RENESAS TECHNICAL UPDATE

Product Category	Transistors		Document No.	TN-PTR-A001A/E	Rev.	1.00
Title	PCN of Marking for Power Transistors		Information Category	Change of Packages		
Applicable Product	All of TO-3P,TO-3PFM,TO-220AB, TO-220FM,TO-220CFM,LDPAK, DPAK,LFPAK,LFPAK-i,WPAK and TSSOP-8	Lot No.	Reference Document			
		All

Renesas Technology will change the marking of TO-3P,TO-3PFM,TO-220AB, TO-220FM,TO-220CFM, LDPAK, DPAK,LFPAK,LFPAK-I,WPAK and TSSOP-8.

[Example for TO-3P(Note:The marking for TO-3PFM is same layout.)]

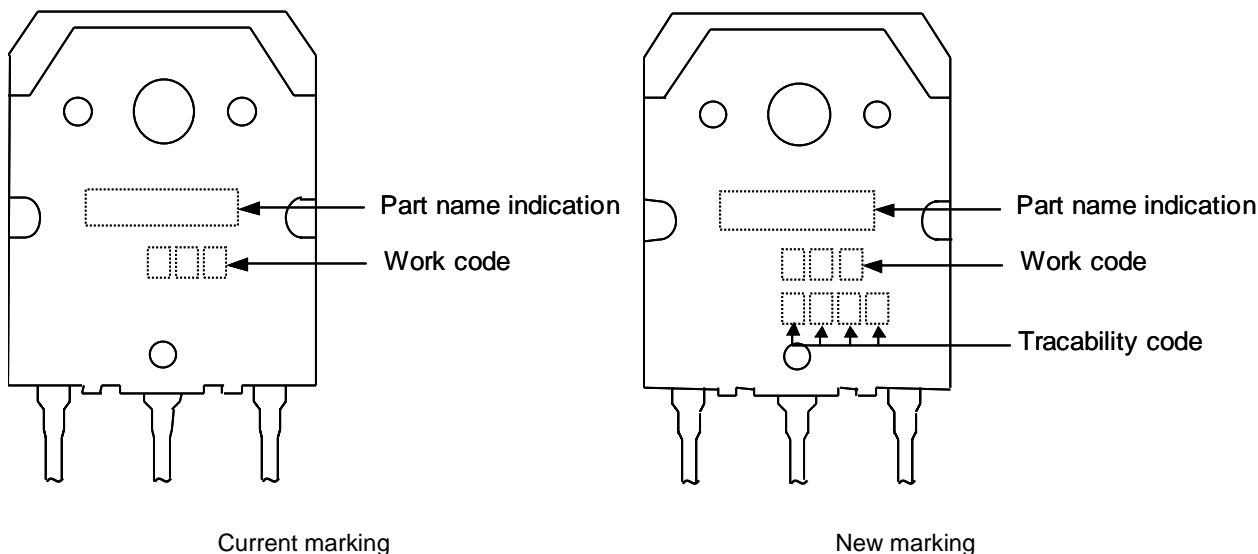
5.1. Cahanging of Marking for TO-3P and TO-3PFM

[Example for TO-220AB(Note:The marking for LDKPAK is same layout.)]

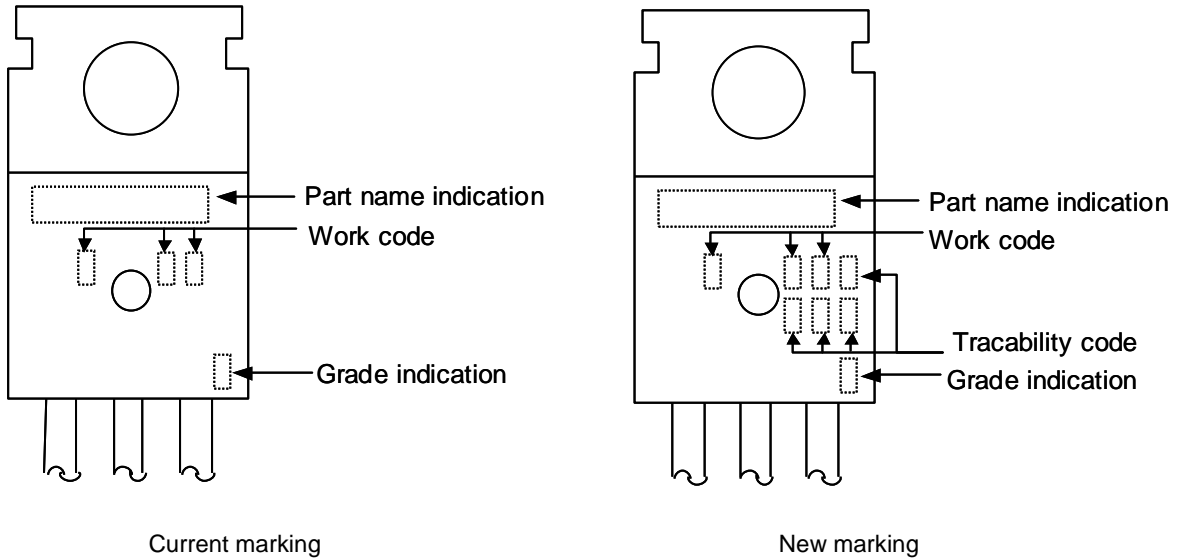
5.4. Changing of Marking for TO-220AB and LDKPAK

[Example for TO-220FM(Note:The marking for TO-220CFM is same layout.)]

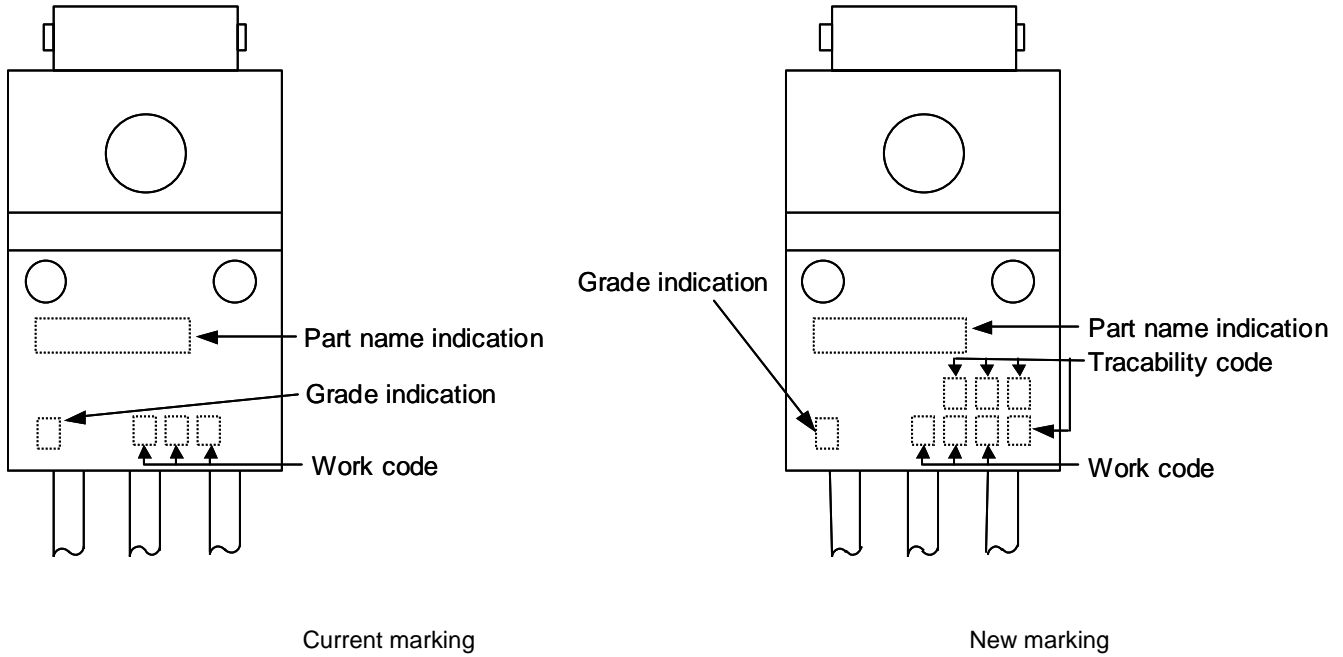
5.7. Changing of Marking for TO-220FM and TO-220CFM

[Example for DPAK]

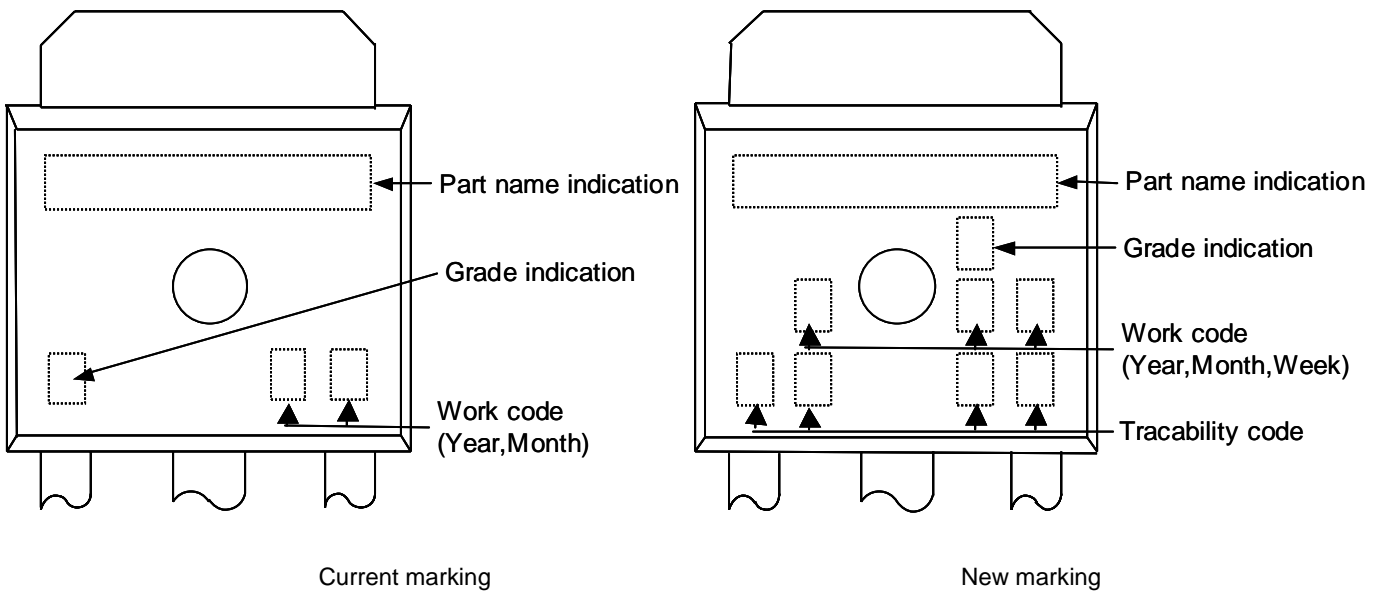
5.10. Cahanging of Marking for DPAK

[Example for LFPAK(Note:The marking for LFPAK-i is same layout.)]

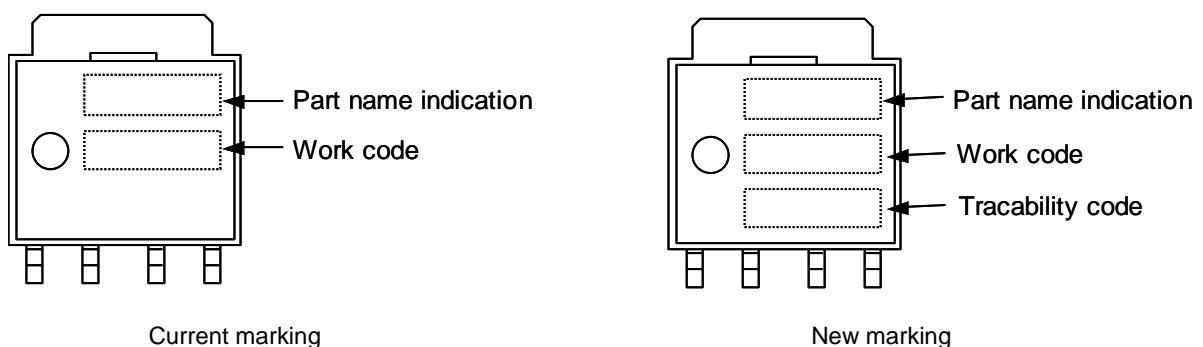
5.12. Cahanging of Marking for LFPAK and LFPAK-i

[Example for WPAK]

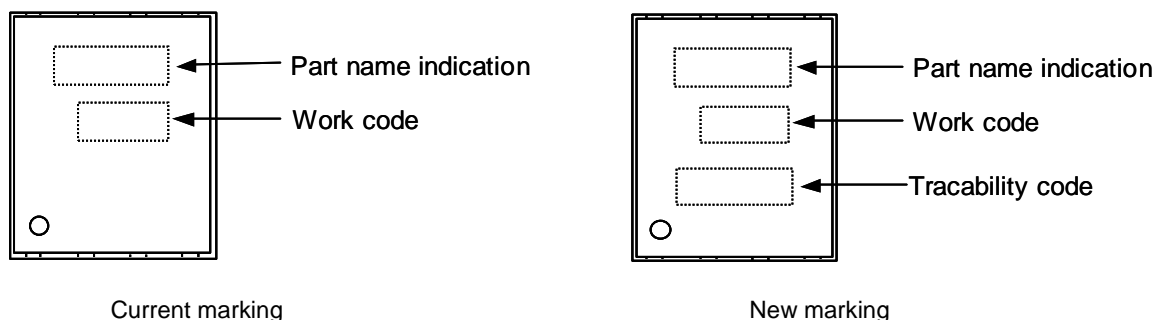
5.15. Cahanging of Marking for WPAK

[Example for TSSOP-8]

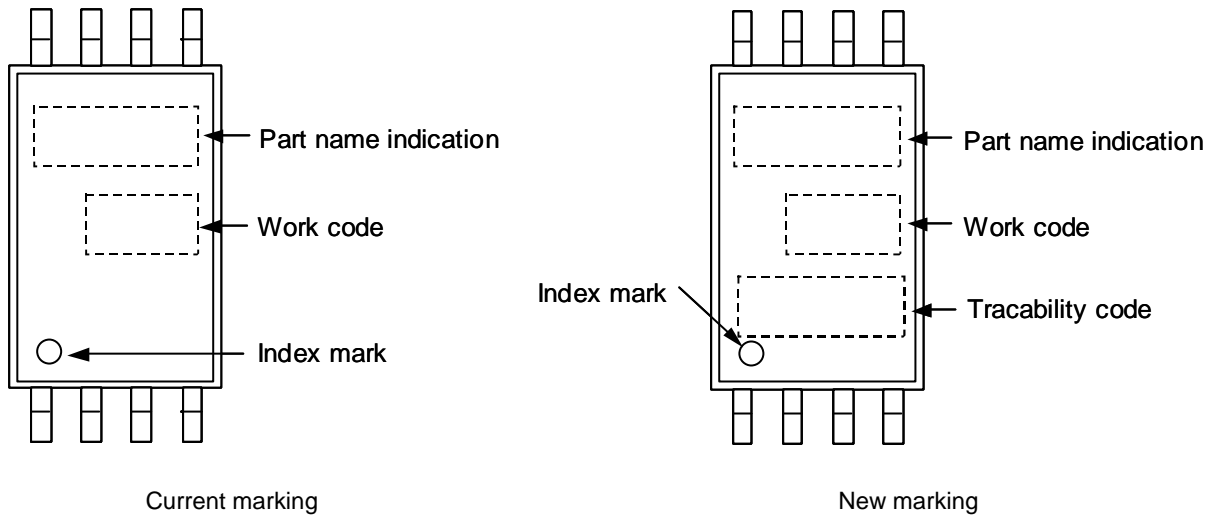
5.15. Changing of Marking for TSSOP-8
